CD-CPC-2025-00075

The applicant seeks to rezone the subject sites to MPD, with an associated development plan, in order to construct two apartment complexes (one on each site).

Neighborhood Planning and Development Committee

2 BUILDING 2 - NORTH ELEVATION
1/8" = 1'-0"

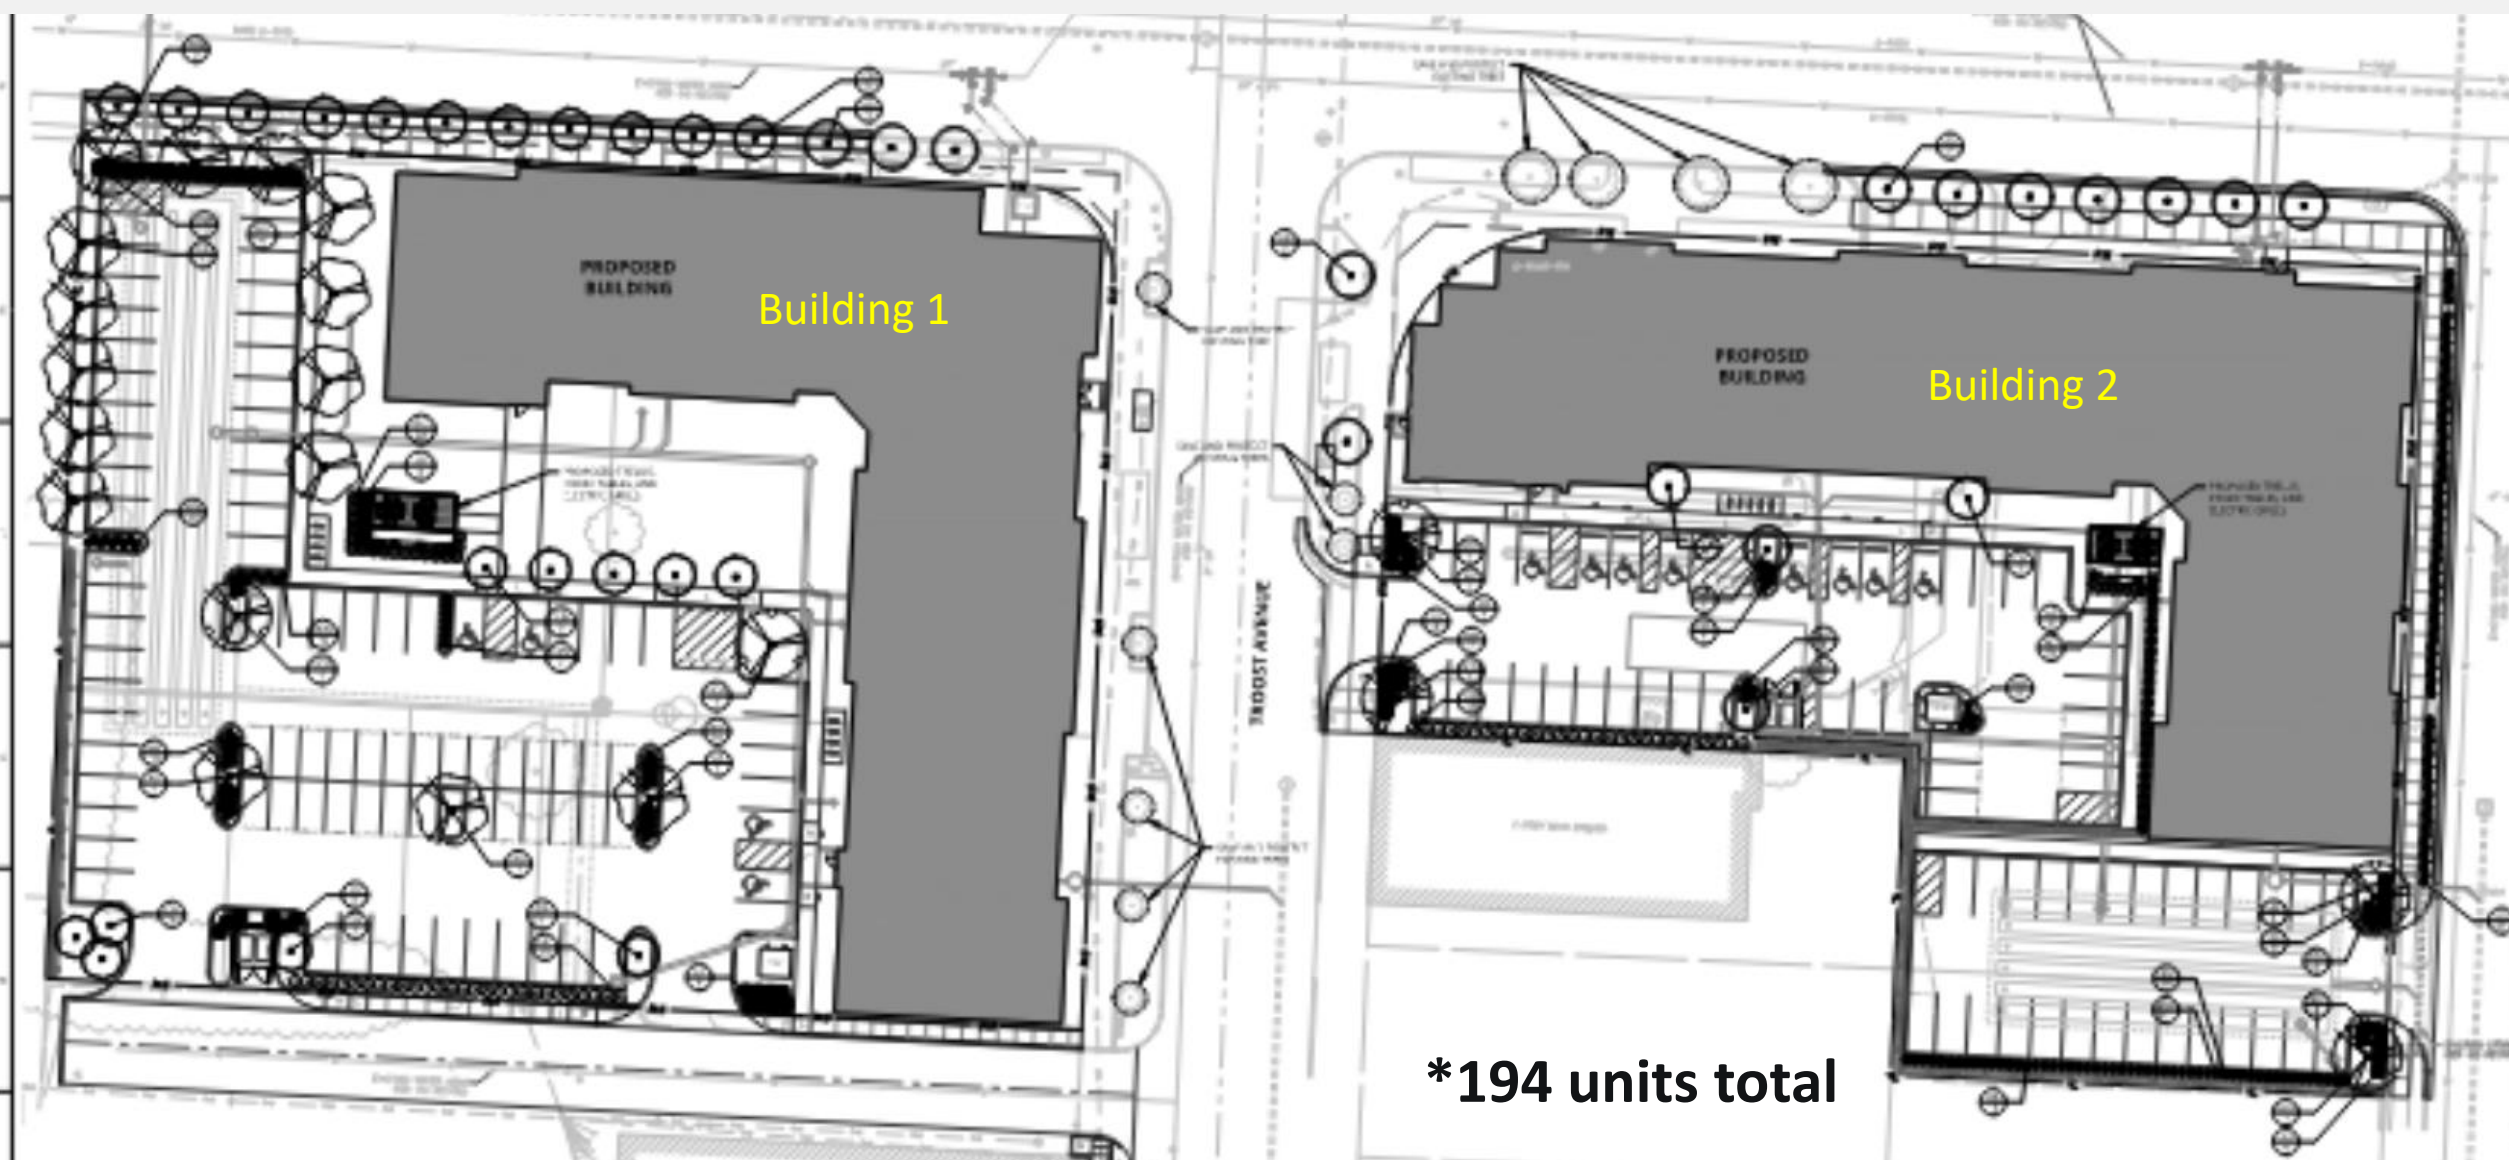
- Location and orientation compatible with adjacent properties.
- Architectural features not compatible with TCO.

Upgrade since V1, with neighborhood discussion, still not in compliance with TCO.
